RE: City of Taunton, MA
WWTF Phase 1 Improvements
Contract S-2021-1

Shop Drawing No. 03200-02 REV 0 – Duct Bank Rebar

SUBMITTAL NO.: 03200-02 REV A

SUBJECT: Duct Bank Rebar

DUCTBANK F-F
APPROX. 510 LF

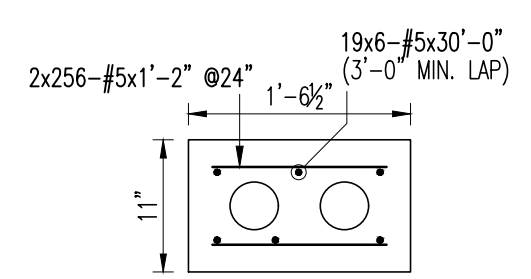
1. Ductbank F-F between Blower Building and the Solids Handling Building will be a (3) DP9 conduit ductbank as indicated on drawing E-0.7.
